## WMCPDR – ROLESVILLE, WENDELL, ZEBULON WATERSHED MANAGEMENT CONSTRUCTION PLAN DISAPPROVAL AND REVIEW COMMENTS

Project Name	Broadmoor	Watershed	Lower Neuse River	Jurisdiction	Rolesville
Date Received	01/14/2025	Date Processing Initiated	01/14/2025	Disturbed Acreage	73
S&E Permit Number	SEC-139136-2025	S&E Plan Review Fee	\$18,250 PAID	S&E Permit Fee	\$18,250 PENDING
SW Permit Number	SWF-139473-2025	SW Plan Review Fee	\$2,500 PAID	SW Permit Fee	\$2,500 PENDING

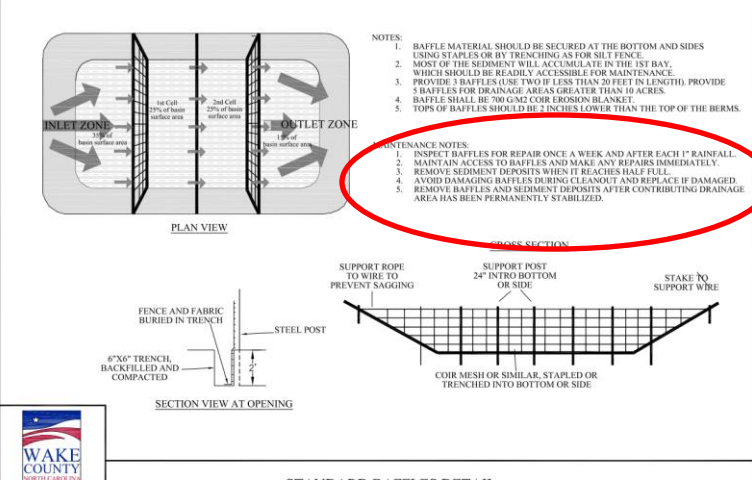
<input checked="" type="checkbox"/>	e.	Support data for all stormwater practice designs, such as inflow/outflow rates, stage/storage data, hydrographs, outlet designs, infiltration rates, water elevations, design output, summary, etc. <b>Recommendation: Provide 100-year-storm calculations to the pond to ensure pond can retain 100-year storm.</b>
<input checked="" type="checkbox"/>	f.	Signature, Date and Professional Seal: for all Stormwater design management proposals, i.e., calculations, BMP designs, operations/maintenance/budget/as built/inspections/manuals <b>-Preliminary mark will need to be removed</b>
<input checked="" type="checkbox"/>	13.	<b>Draft Stormwater Agreement and draft Maintenance Agreement</b> <b>*Did not see this in 03/05/2025 submittal</b>
<input checked="" type="checkbox"/>	14.	Proposed Site Plan:
<input type="checkbox"/>	a.	<a href="#">Combined Erosion Control, Stormwater and Floodplain Approval Block</a> (Cover Sheet)

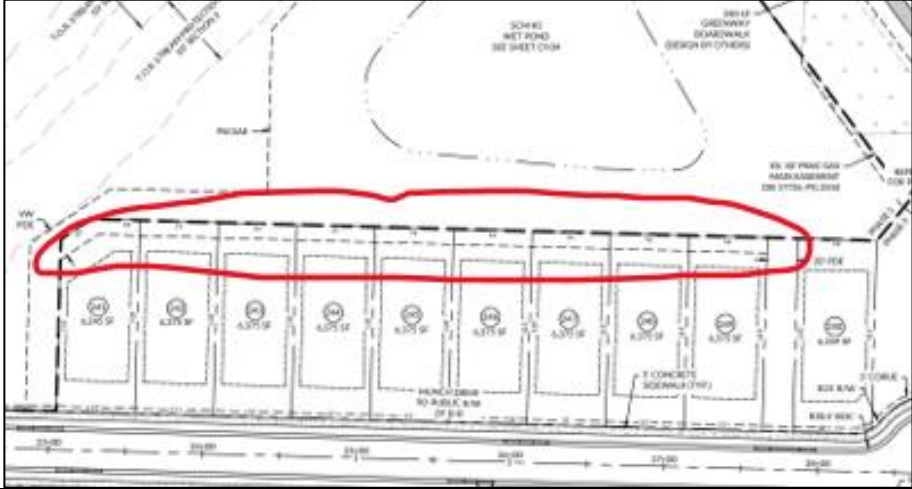
<input checked="" type="checkbox"/>	f.	Table with impervious calculations - existing and proposed impervious surfaces: roads, well lots, recreation sites, single family residences, etc. (consistent with the Municipal Stormwater Design Tool inputs) <b>-Revise Impervious table to only show impervious areas.</b>
<input type="checkbox"/>	g.	Proposed improvements: roads, buildings, parking areas, grassed, landscaped and natural areas
<input type="checkbox"/>	h.	Lot lines, lot numbers, road names, and impervious limit on each lot rounded to nearest whole number
<input type="checkbox"/>	i.	Utilities: community water and sewer, plan/profiles, easements and sediment controls
<input type="checkbox"/>	j.	Stormwater Network: inlets, culverts, swales, ditches, channels and drainage easements
